DDS- Planning & Zoning: Plan Review Application

HOG RIVER BREWERY RELOCATION
1420 Park St.
Hartford, CT 06106

From: Paul Ashworth
Sent: Wednesday, July 13, 2022 3:34 PM
To: Berschet, Paige; Natalie Sweeney
Cc: Hartford Planning Division
Subject: RE: 1420 Park St - Special Permit Application - P&Z-COMM-2022-0264

Special Permit Application for Approval of Use of an proposed Accessory Outdoor Café associated with a Drinking Place per Section 3.5.2. D, to be reviewed in a CX-2/TOD Zone.

EXTERIOR FACADES

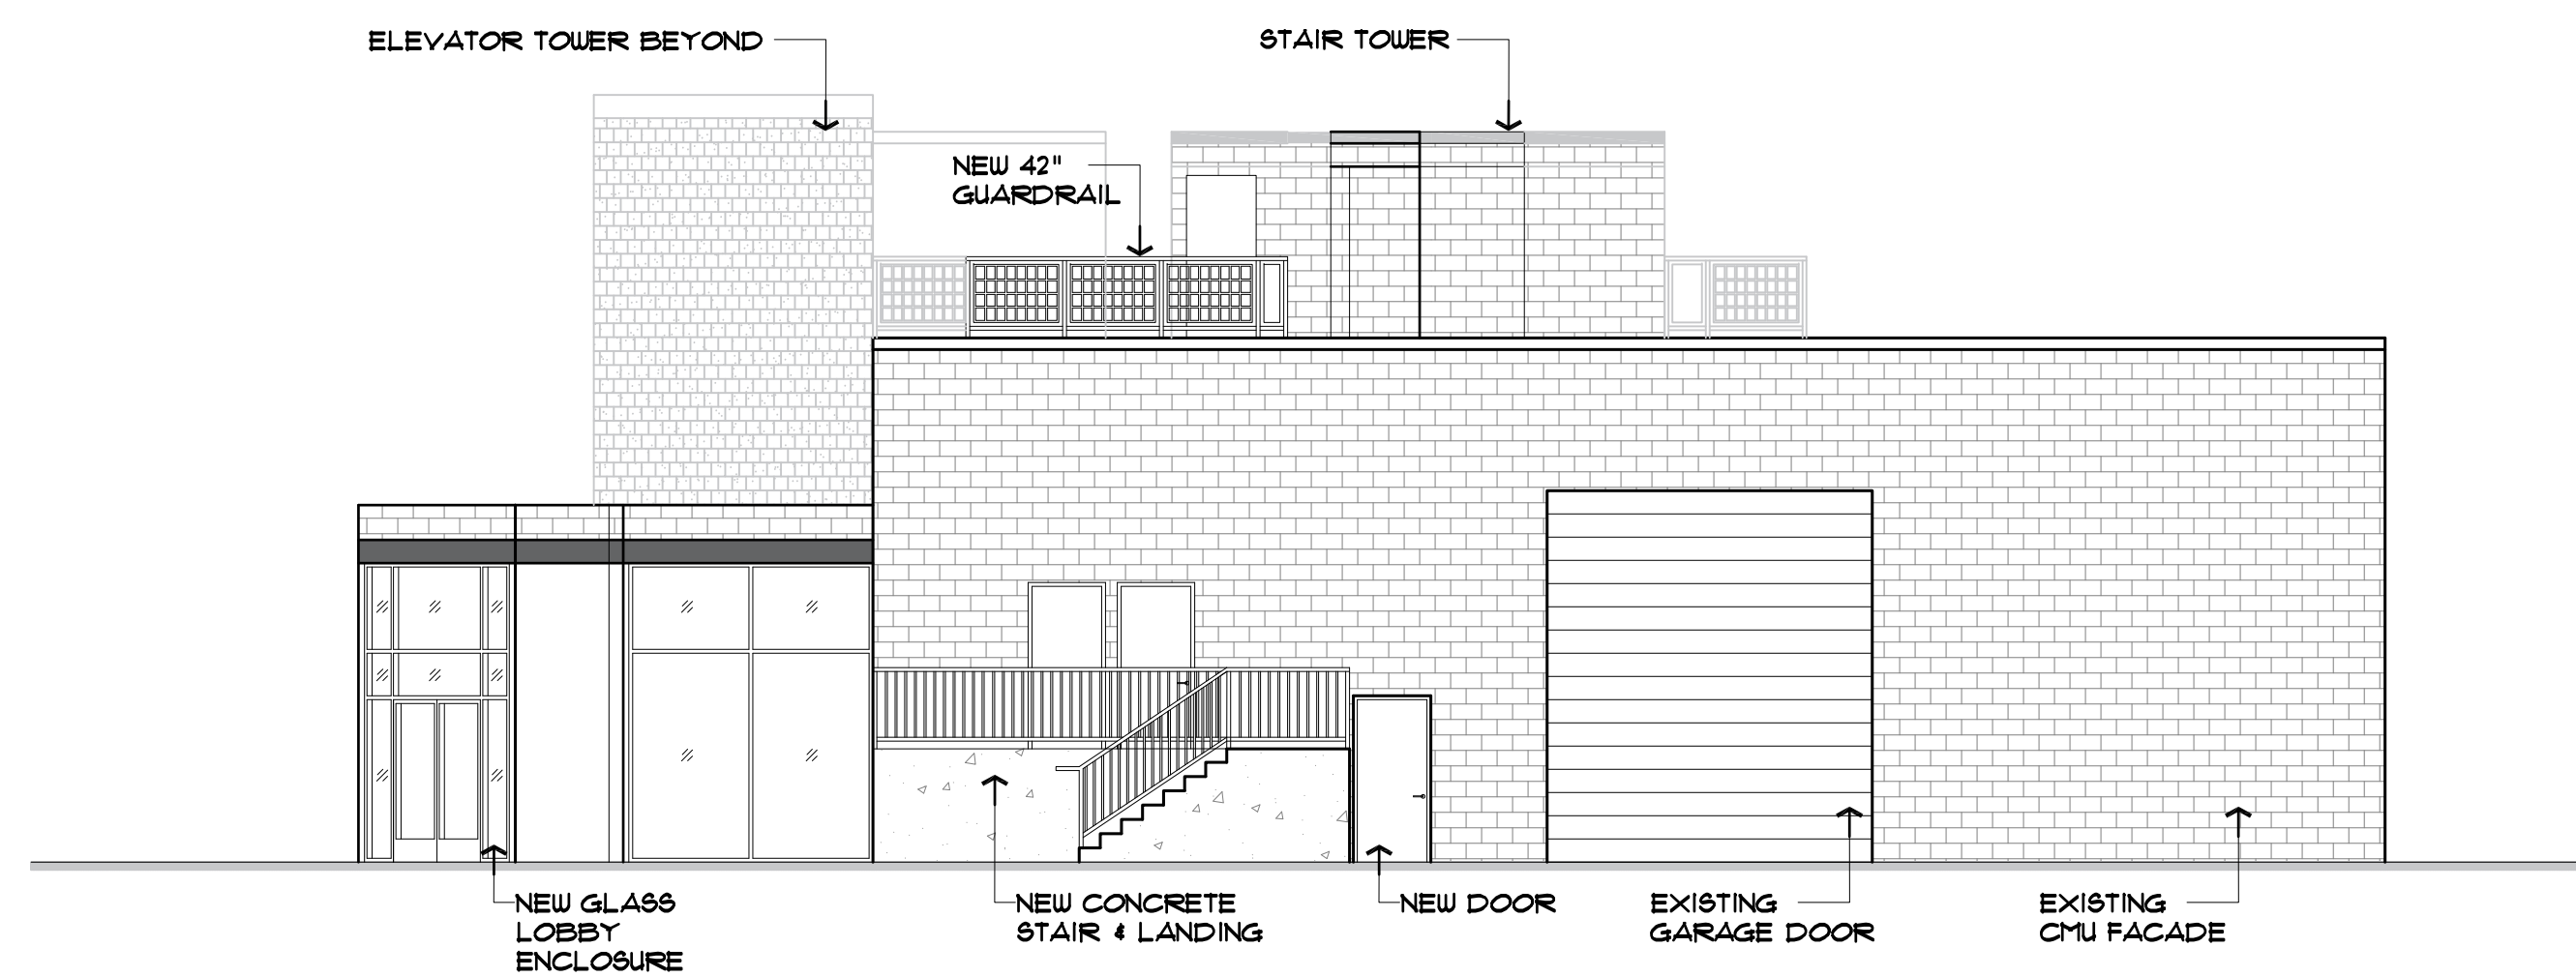
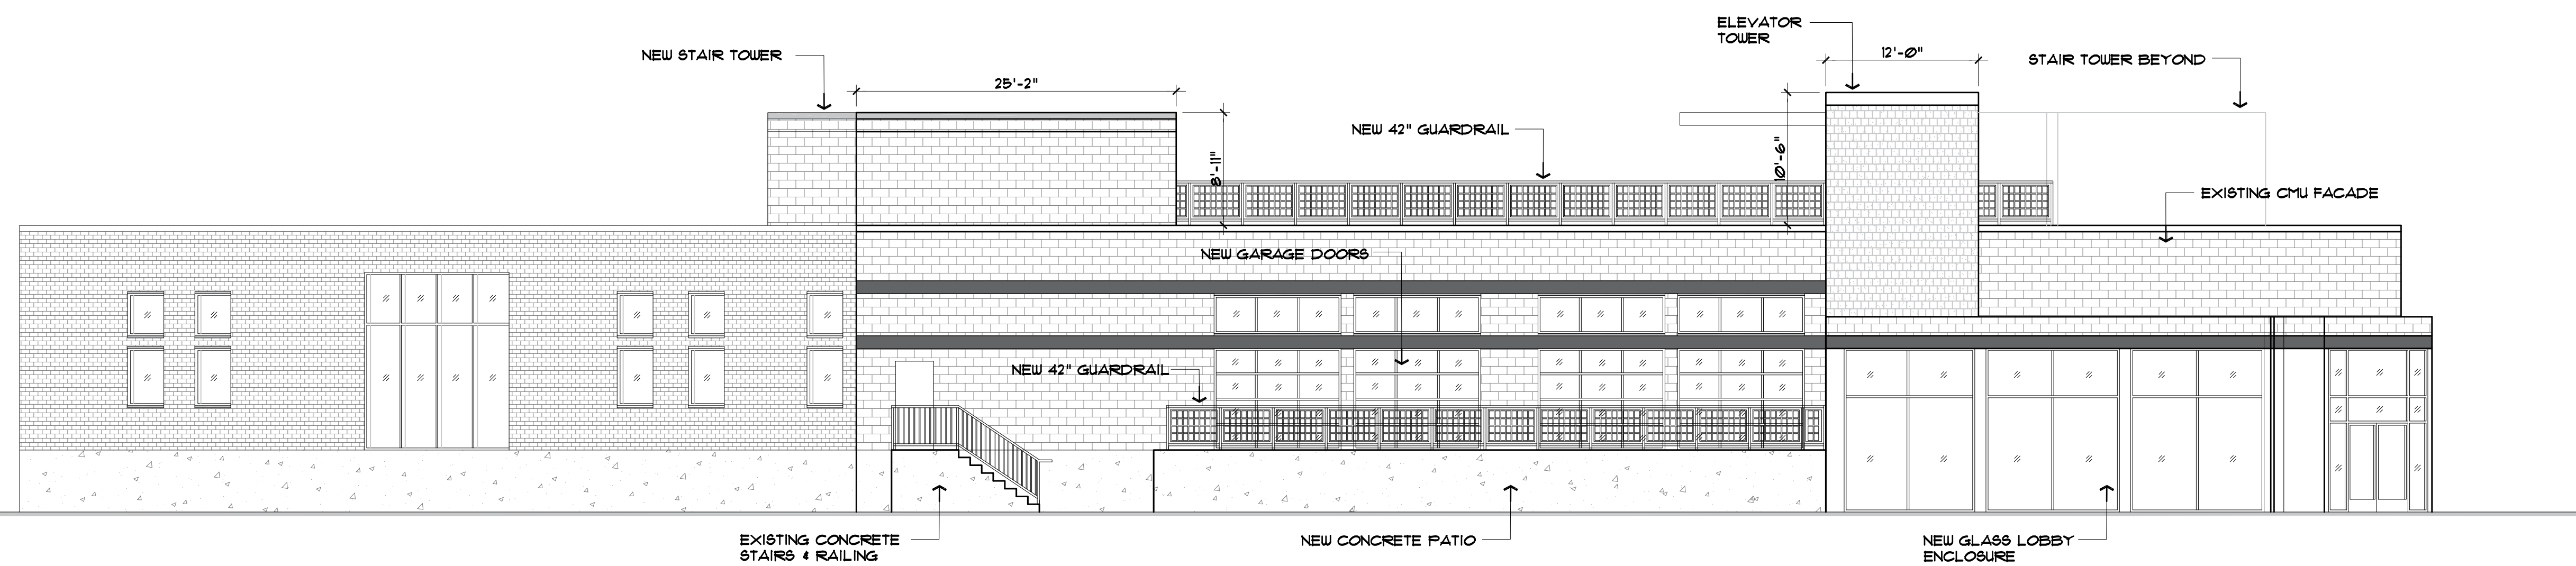
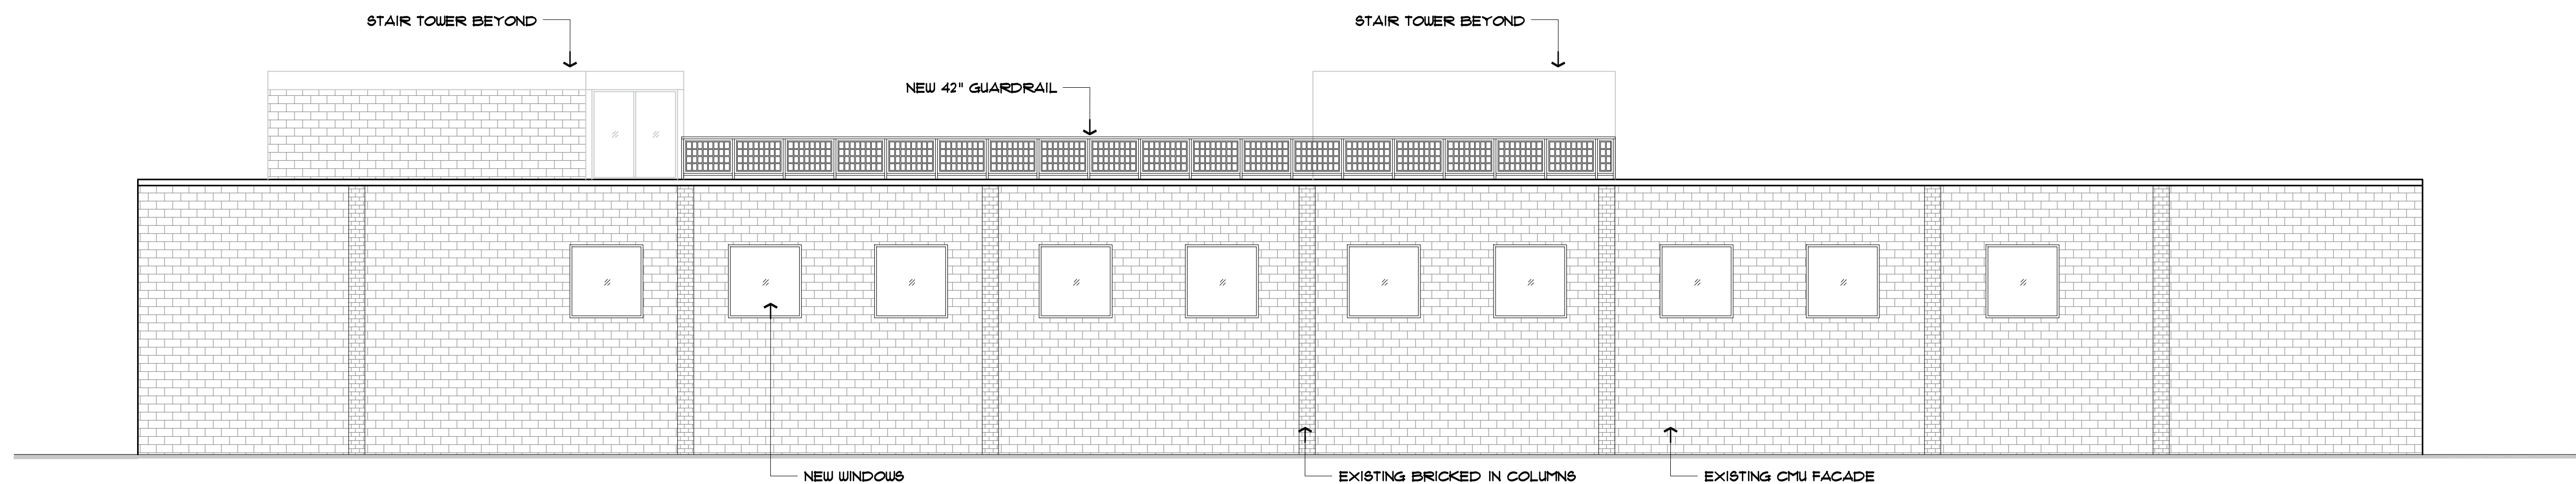
3. I noticed that the proposed elevation drawings do not match what was approved by the historic preservation board 12/15/21 (COMM-2021-0548). **Paige Berschet** will confirm whether this will require additional review by HPC.
